DOCUMENT 00 90 00
ADDENDUM

ADDENDUM: 1

DATE: APRIL 14, 2025

PROJECT: IOWA-GRANT SCHOOL DISTRICT
LOCKER ROOM RENOVATION
462 IOWA GRANT ROAD
LIVINGSTON, WISCONSIN 53554
PROJECT NO. 25007

2 SECOND FLOOR POWER PLAN

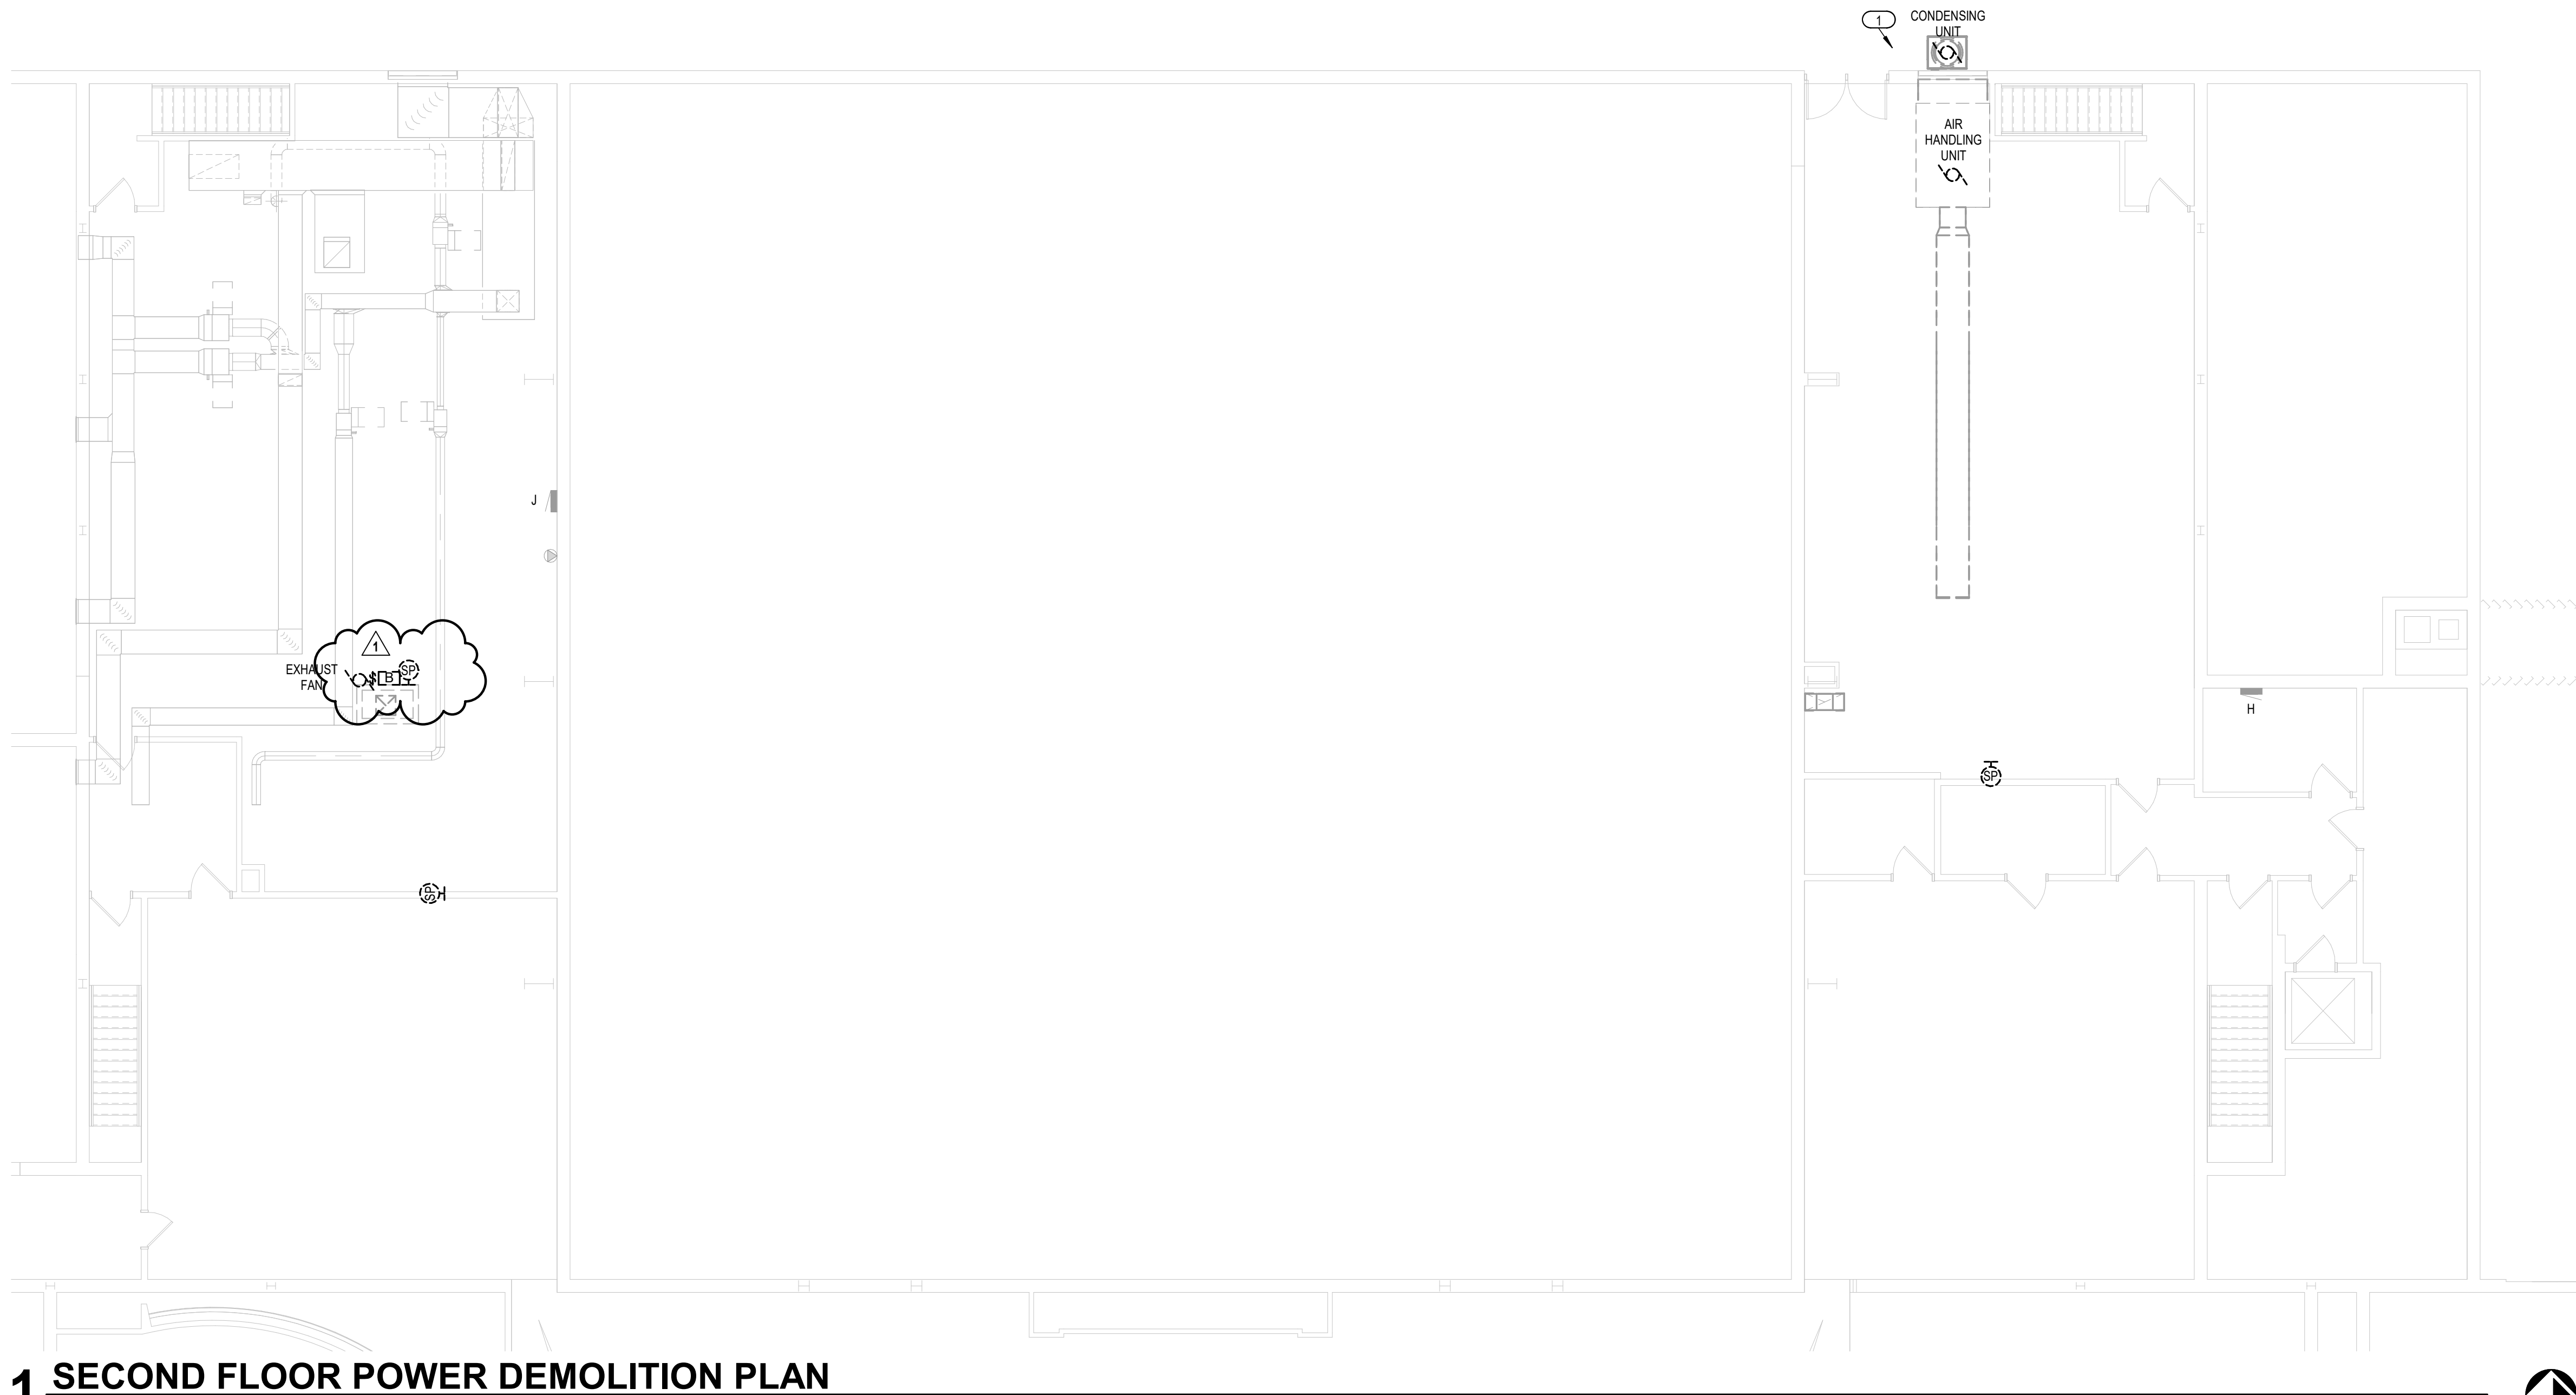
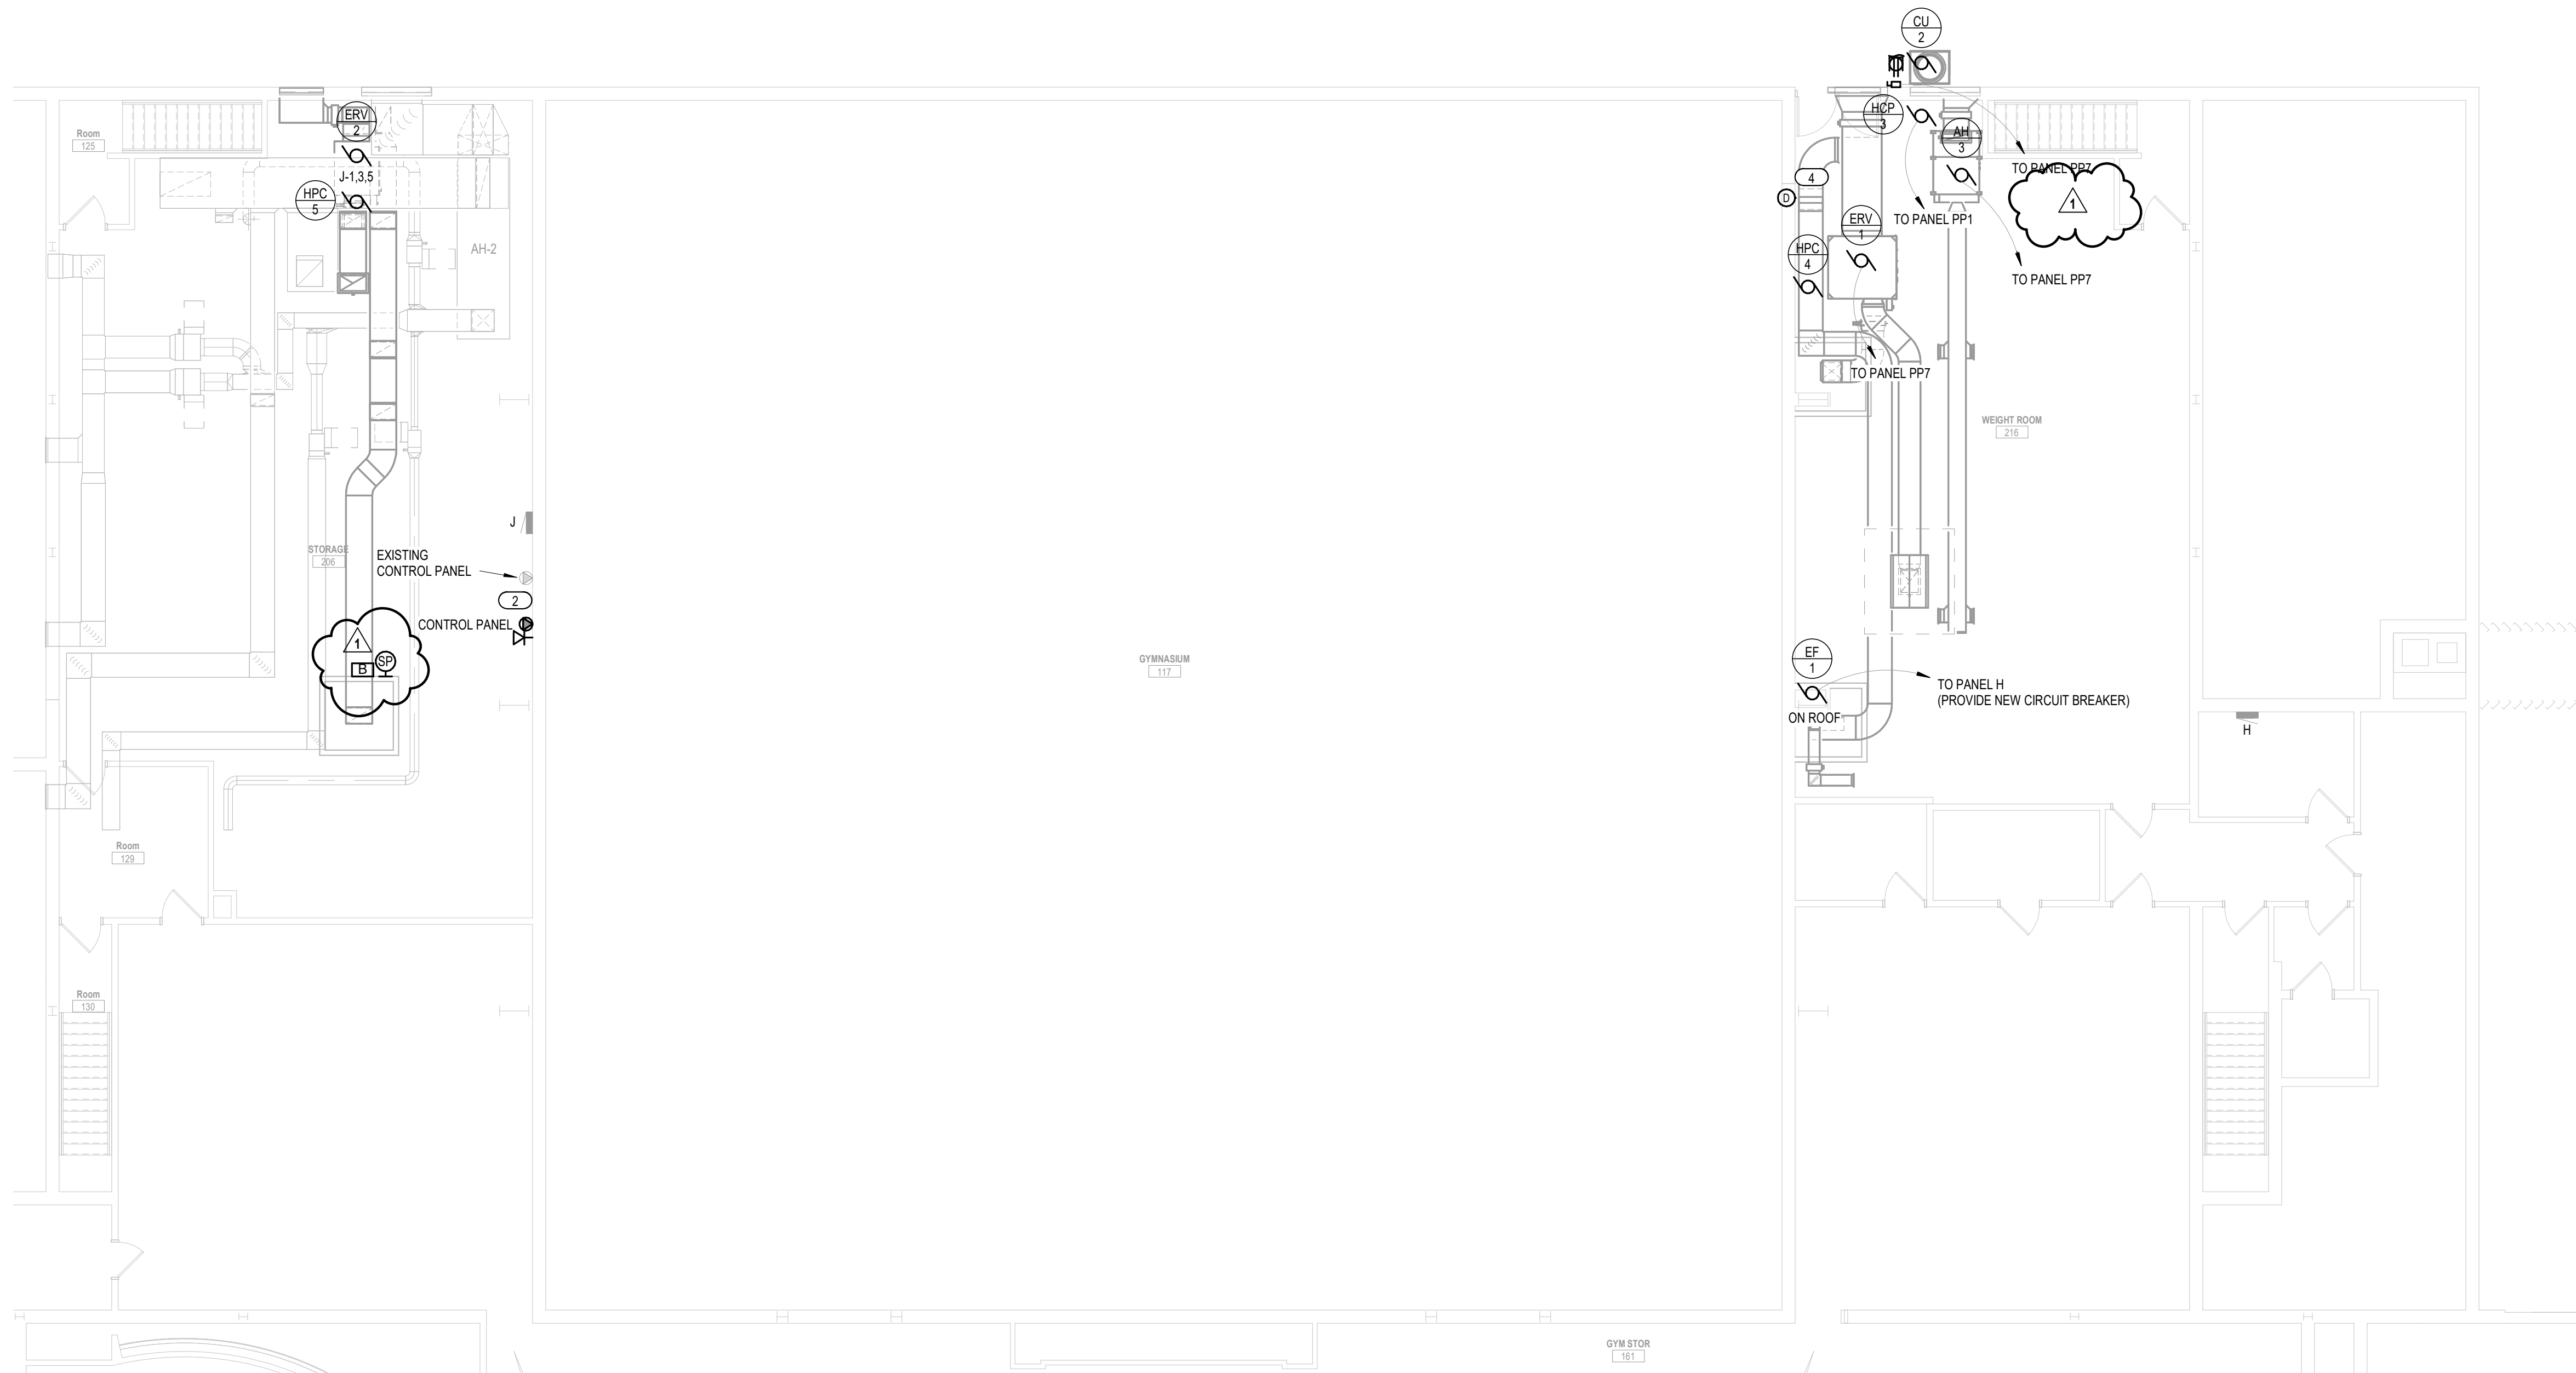
16. Sheet E121 FIRST FLOOR POWER & SYSTEMS PLAN 30"x42"
 - a. See the revised sheet included in this addendum. Disregard the previous version.
 - b. Revise location of control panel.
 - c. Add scoreboard repeaters.
17. Sheet E212 SECOND FLOOR ELECTRICAL PLAN 30"x42"
 - a. See the revised sheet included in this addendum. Disregard the previous version.
 - b. Revise location of control panel.
 - c. Demo / Add bell and speaker.
